# UNITED STATES PATENT AND TRADEMARK OFFICE

| APPLICATION NO. | FILING DATE | FIRST NAMED INVENTOR | ATTORNEY DOCKET NO. | CONFIRMATION NO. |
|-----------------|-------------|----------------------|---------------------|------------------|
| 09/940,949      | 08/28/2001  | Luc Tripod           | PU010180            | 5192             |

# Office Action Summary

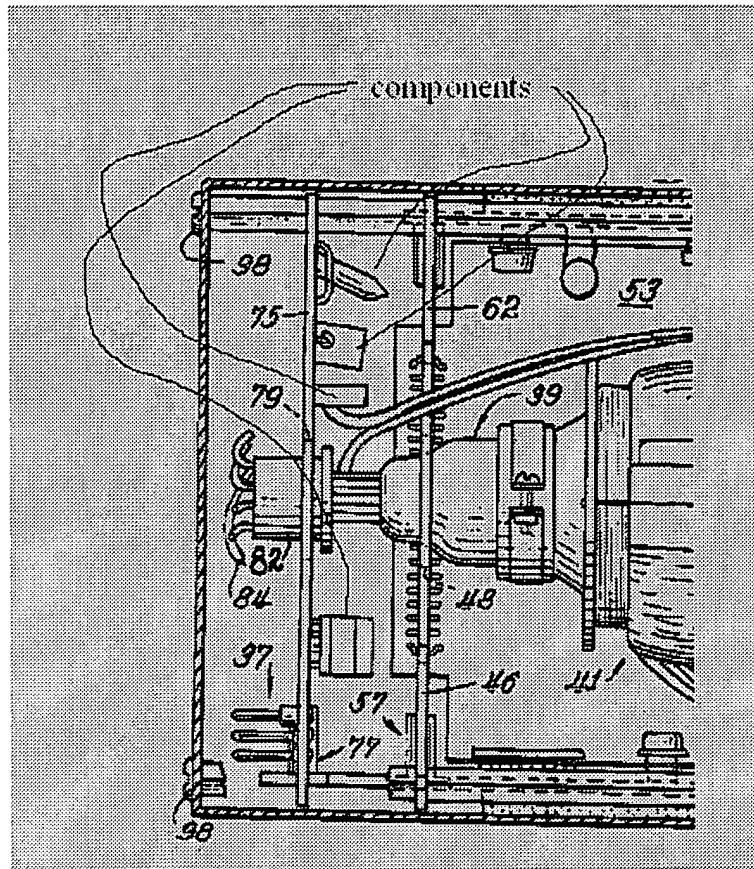
-- In reference to claims 2 and 8, Puhak shows substantially the invention as claimed. However, Puhak does not show the circuit board has a plurality of components mounted thereon, none of the components extending away from the funnel further than the back cover of the socket.

Johnson shows (cover sheet) the circuit board 75 has a four (a plurality) components (see examiner's figure) mounted thereon, none of the four components extending away from the funnel further than the back cover of the socket.

It would have been obvious to one of ordinary skill in the art at the time the invention was made to use the component configuration shown by Johnson on the circuit board of Puhak because, as shown by Johnson (cover sheet), if the components were mounted on the other side of the circuit board, it would not make it possible to use wire 86 to electrically connect at least one of the plurality of components to the funnel.

-- In reference to claim 3, Puhak as modified by Johnson shows (figure 8 ) the circuit board has a plurality of components (see examiner's figure) mounted on the first side.
